Metro Tunnel Project

Park Street Tram Stop Development Plan Addendum

December 2020

Figure 1.1 Amendment works

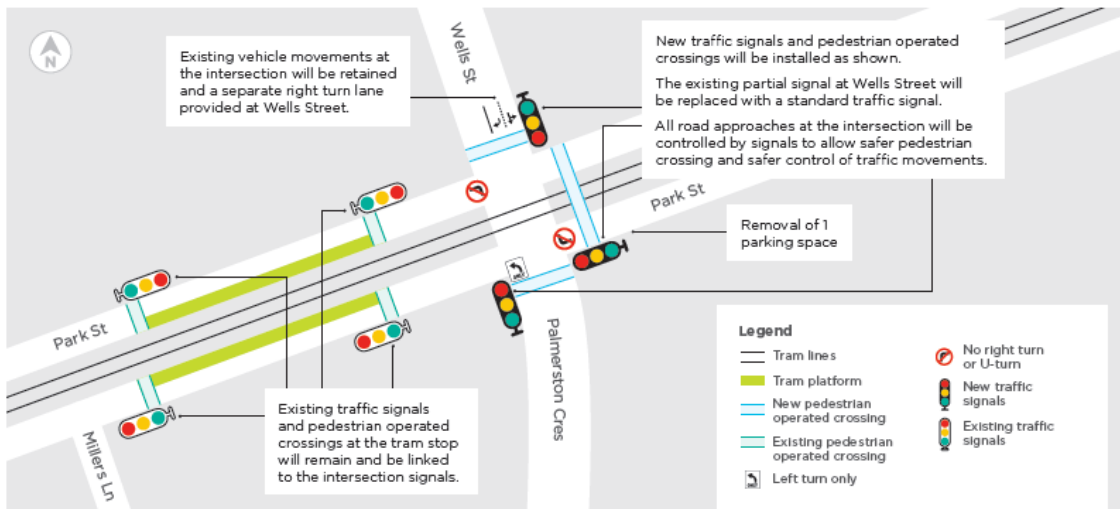
The purpose of this Amendment is to address the safety upgrades raised in a Road Safety Audit conducted in 2019. In summary, the works include:

- Safety improvements including the installation of traffic control signs and associated infrastructure and the removal of redundant traffic elements (where required).
- Installation of a right turn lane on Wells Street.
- Removal of one car space on Park Street, South Melbourne to meet safety and functionality requirements for the signalisation works.

Figure 3.1: Amended works

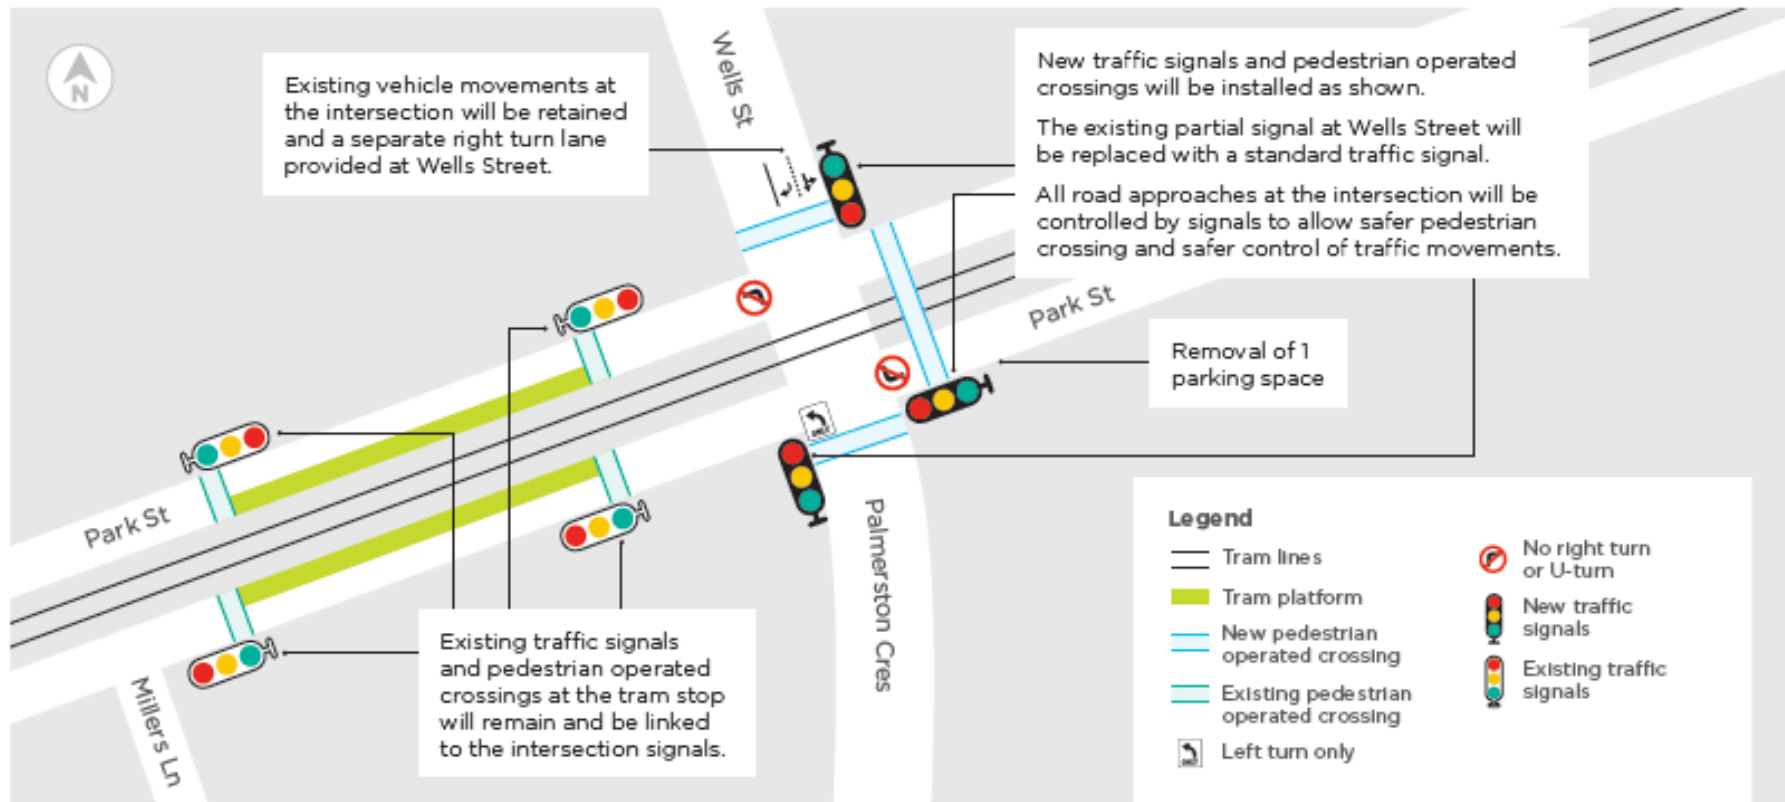
The proposed works include but are not limited to:

- Installation of traffic & tram control signals and associated infrastructure
- Installation and alteration of utility, communications and electrical infrastructure to facilitate the proposed works.
- Installation of a right turn lane on Wells Street
- Removal of redundant traffic control elements such as traffic islands
- Removal of one car space on Park Street to meet the safety and functionality requirements for the traffic control signals
- Installation of safety improvements including but not limited to upgrading street lighting and the installation of safety fencing (as required)
- Other works including road resurfacing to match existing surfaces and installation of associated line marking. There will be no change to existing ground surface levels.

Figure 3.1 below further details the proposed works.
